Errata to the Final Revised EIR

Since publication of the Final Revised Environmental Impact Report (EIR) for the Flood County Park Landscape Plan in October 2019, the San Mateo County Parks Department has undertaken the following actions that require text amendments to the Final Revised EIR:

Figure 5 Proposed Parking Map

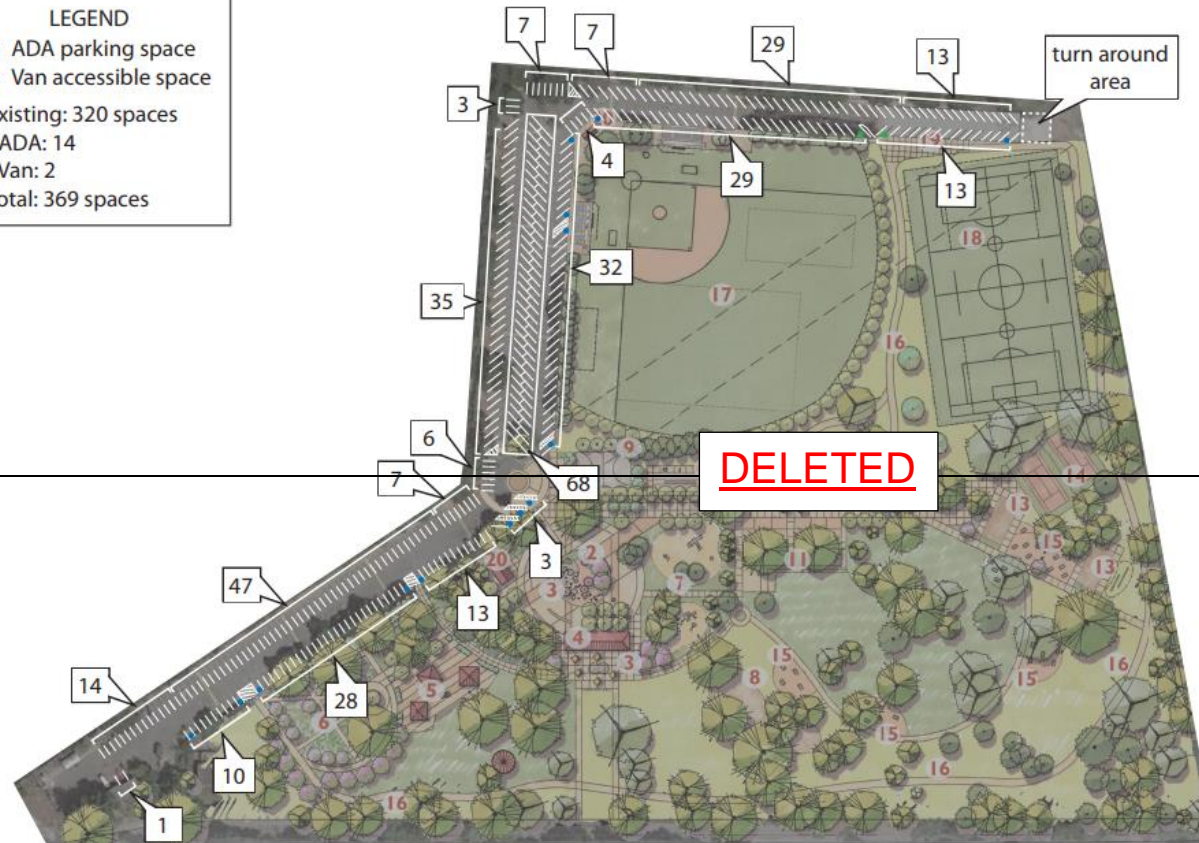
Pedestrians also would retain access to the park through entrances gaps along Bay Road and at the eastern gate from Iris Lane. An additional 26 parking spaces and a turnaround area would be added to the site of the existing pétanque court, as shown in Figure 4 and Figure 5, Proposed Parking Map. Twenty-three (23) new parking stall locations have been identified throughout the site in existing paved areas and include the following: one parking stall near the existing pay station; two

parking stalls in the island near the eastward turn near the ballfield; one stall in the island behind the ranger residence; one stall in the island on the south side of the eastward turn; seven stalls in the approximately 60 foot space and four stalls in the approximately 36 foot space before the pétanque court; and seven stalls by converting ADA van parking stalls to ADA car parking stalls. Therefore, an additional 23 stalls striped outside of the pétanque court and 26 stalls striped within the pétanque court would add a total of 49 new parking spaces at Flood Park. Please see Figure 5 for a layout of all 369 parking spaces. With the additional 49 parking spaces the Park would provide a total of 369 parking spaces.

Figure 1 Proposed Landscape Plan

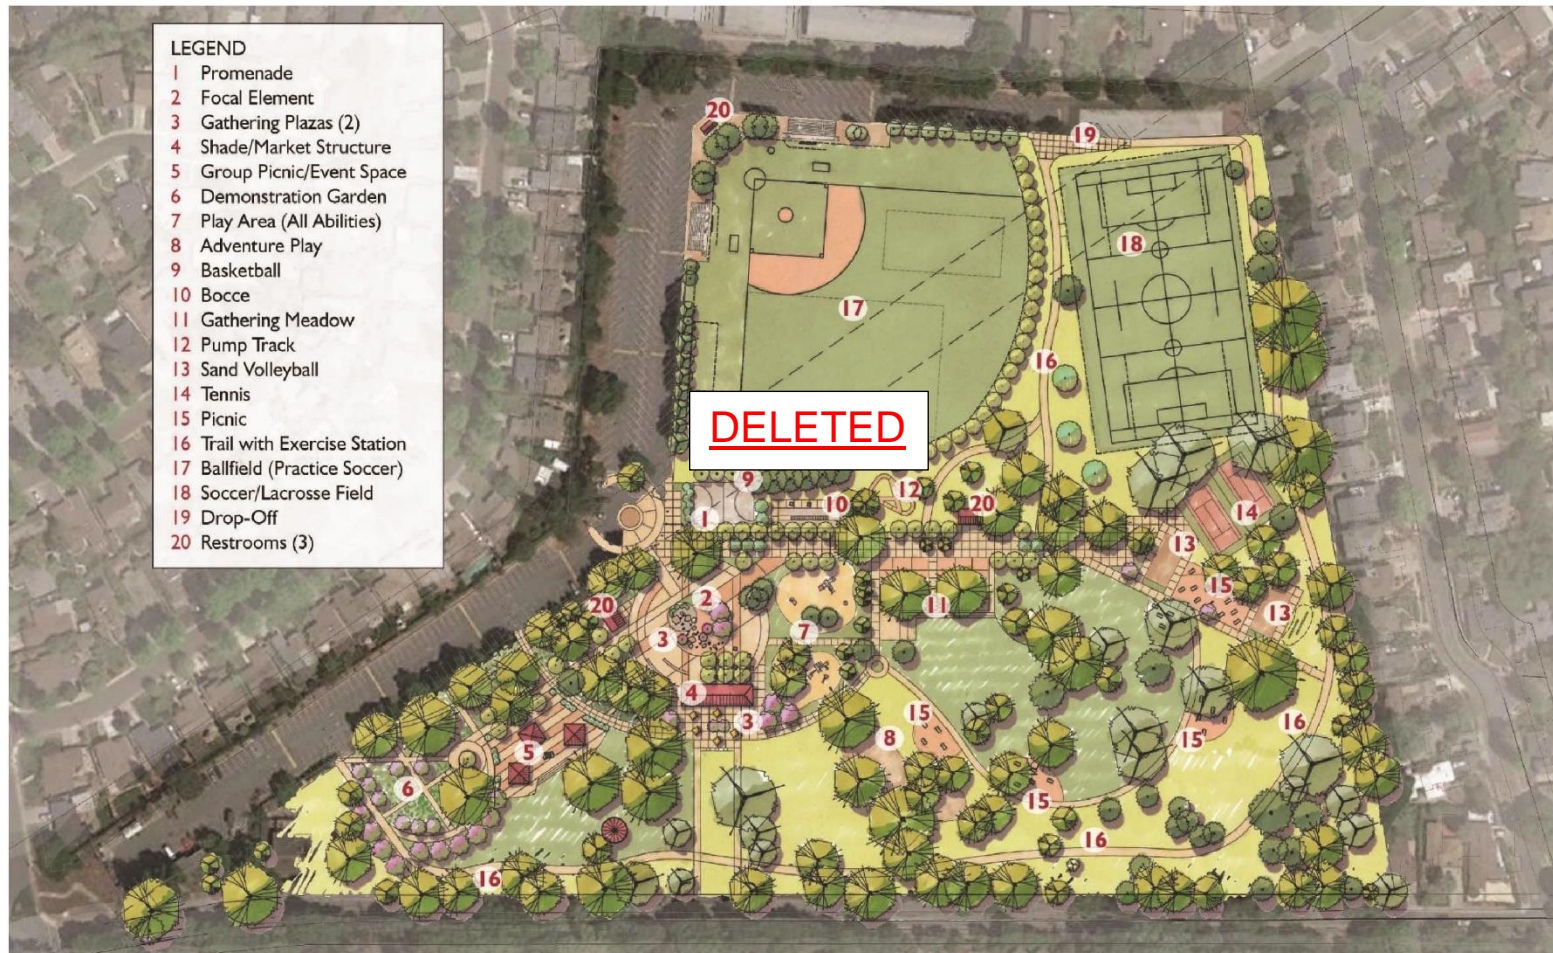
The commenter states that a soccer court should be added to the project design. As shown in Figure 4, the January 2020 update to the Landscape Plan includes two proposed soccer facilities: a multi-use field for baseball/softball, soccer, and lacrosse, and a separate soccer/lacrosse field.~~As stated on page 27 of the Draft Revised EIR, “[a] soccer/lacrosse field (approximately 430 feet long by 260 feet wide) would be installed at the eastern corner, replacing the existing pétanque court and a portion of the existing tennis courts.”~~

Figure 4 shows the layout of recreational facilities in the proposed Landscape Plan. As shown in this figure, the County has committed to siting all active recreational facilities including athletic fields and tennis courts at least 100 feet away from the property line adjacent to residences on Del Norte Avenue. Passive uses, like walking paths and group picnic areas, would be allowed in this setback. The following recreational facilities would be located within the SFPUC right-of-way: the multi-use ballfield/soccer/lacrosse field, basketball court, promenade, and a picnic area.

PROJECT DESCRIPTION

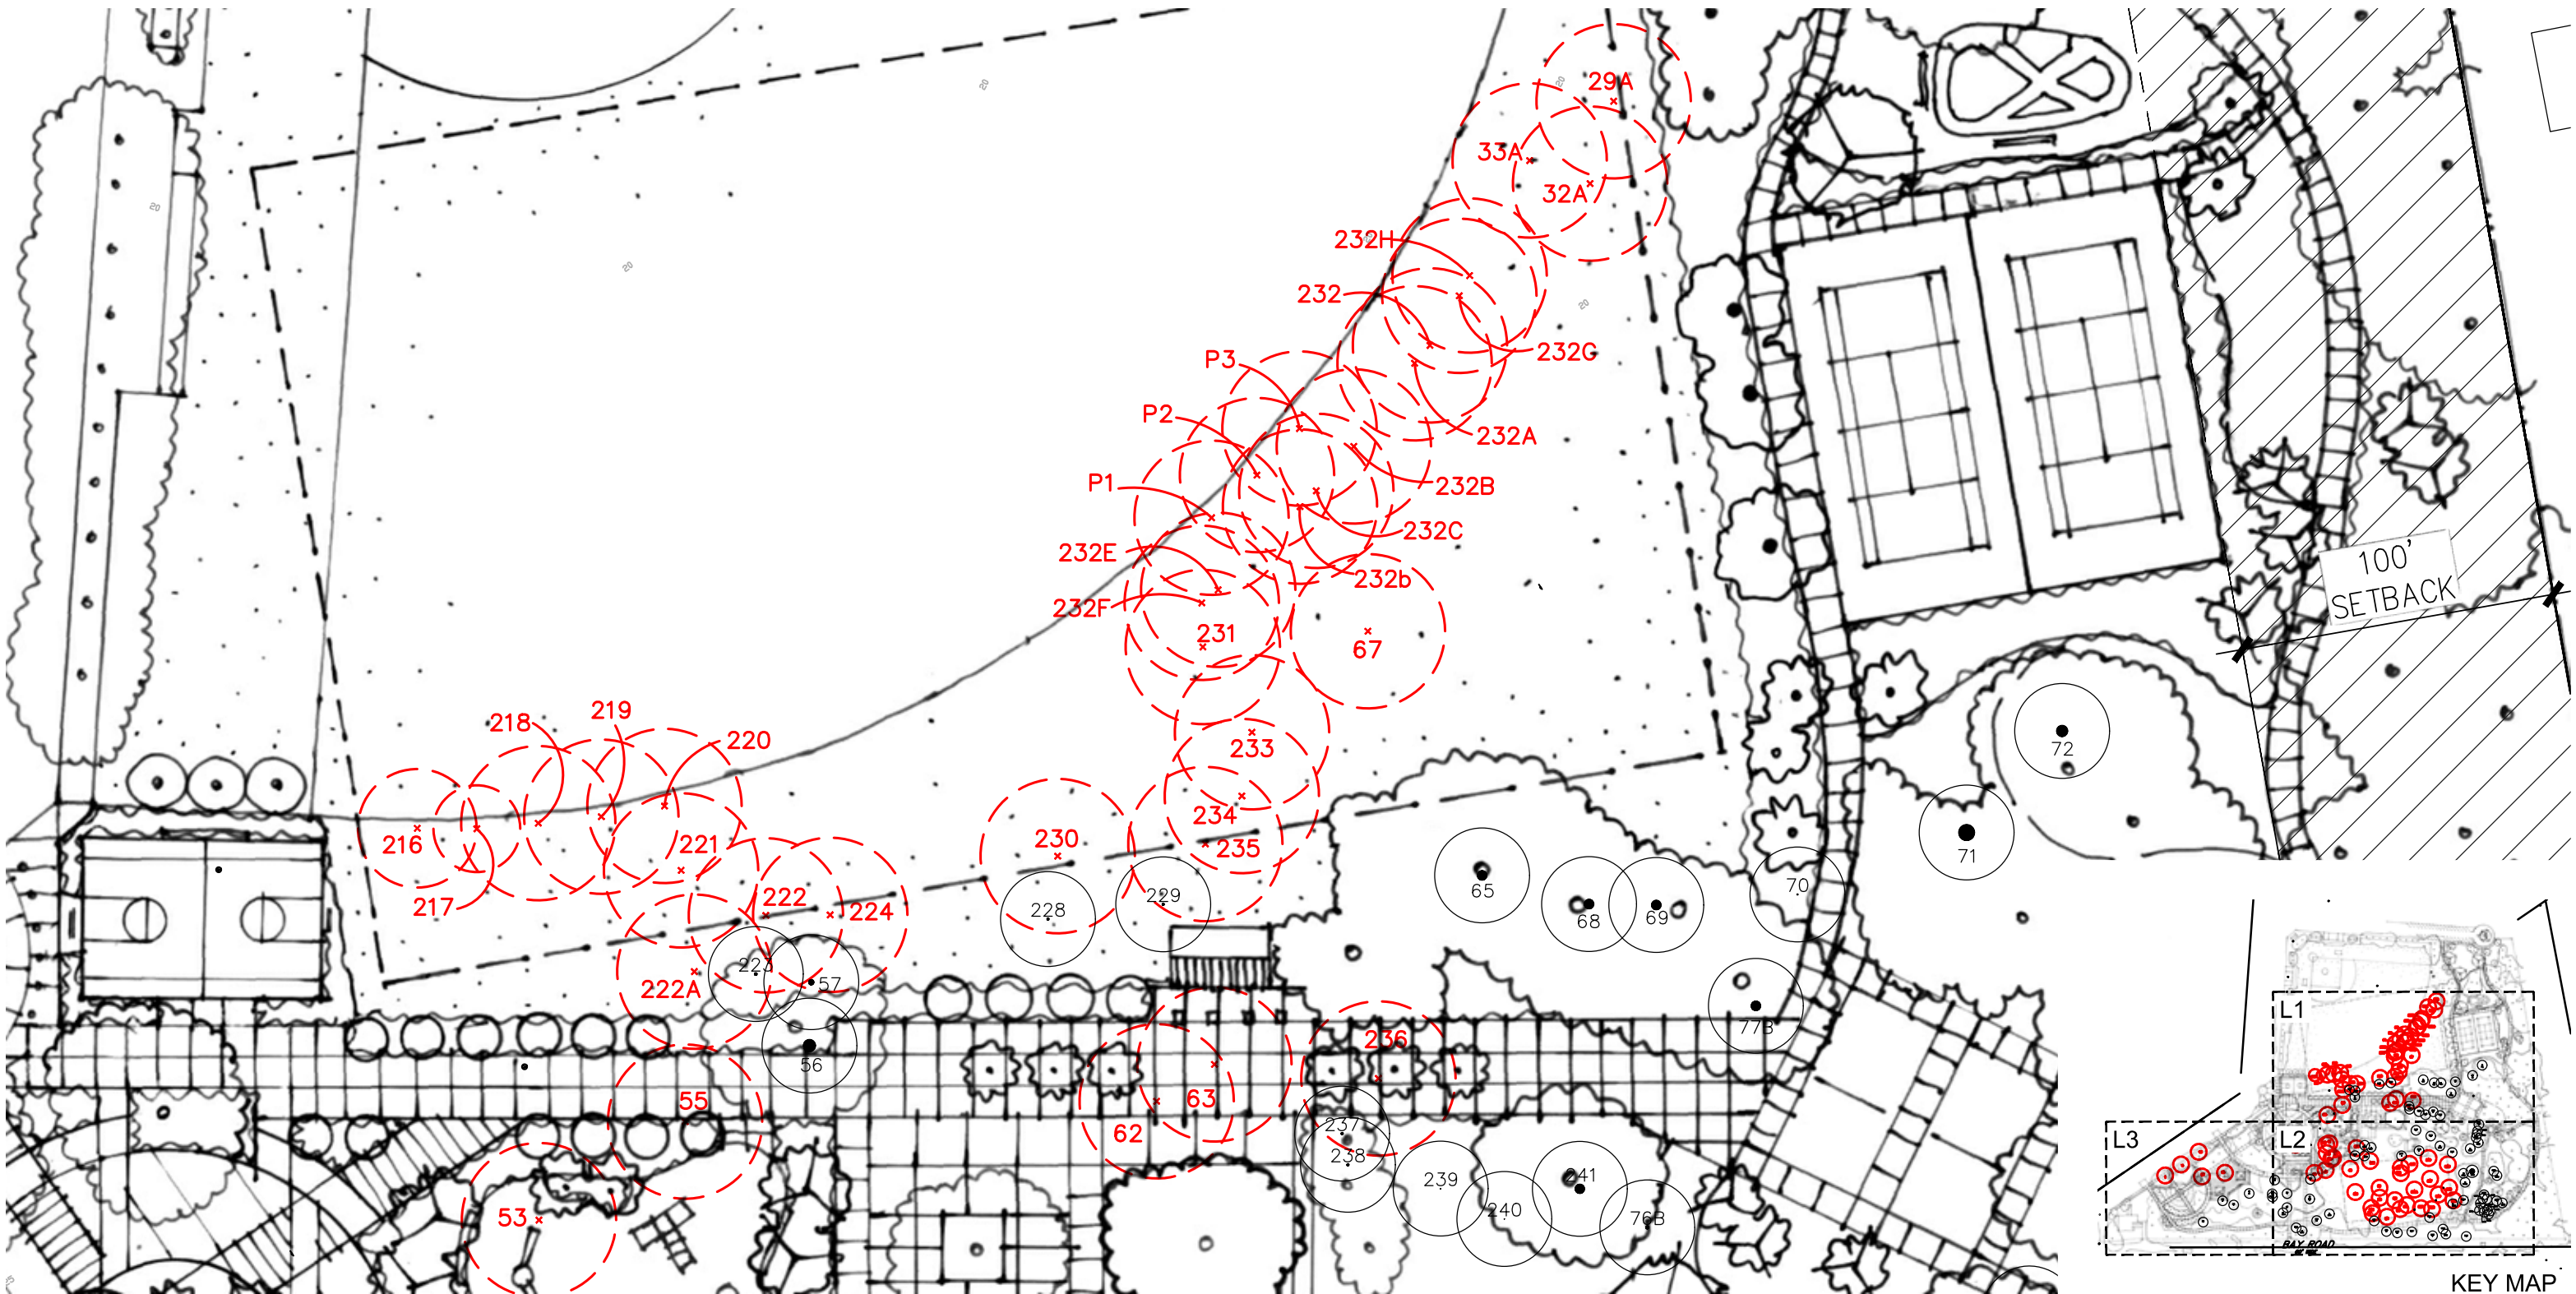
The Revised EIR, dated 2019, evaluated the 2016 Landscape Plan's impact on trees. This updated report identifies trees potentially impacted by the Flood Park Landscape Plan dated January 2020. As part of this update, additional trees were assessed to address the Landscape Plan modifications. There are more than 900 trees in Flood County Park, and this report inventories over 300 of these trees. Trees not inventoried in this report are not anticipated to be impacted by the Landscape Plan.

This report identifies trees that would be removed in the implementation of the 2020 Landscape Plan and compares the cumulative tree removal impact with the 2016 Landscape Plan. The Plan is at a "planning" level of detail and, as such, depending on the exact location, configuration and construction requirements of improvements, may undergo refinement as the project moves toward implementation. In subsequent phases, more detailed information will become available that allows adjustments to be made to address specific site conditions. As such, this report should be considered an approximation of tree removal given the current level of design detail.
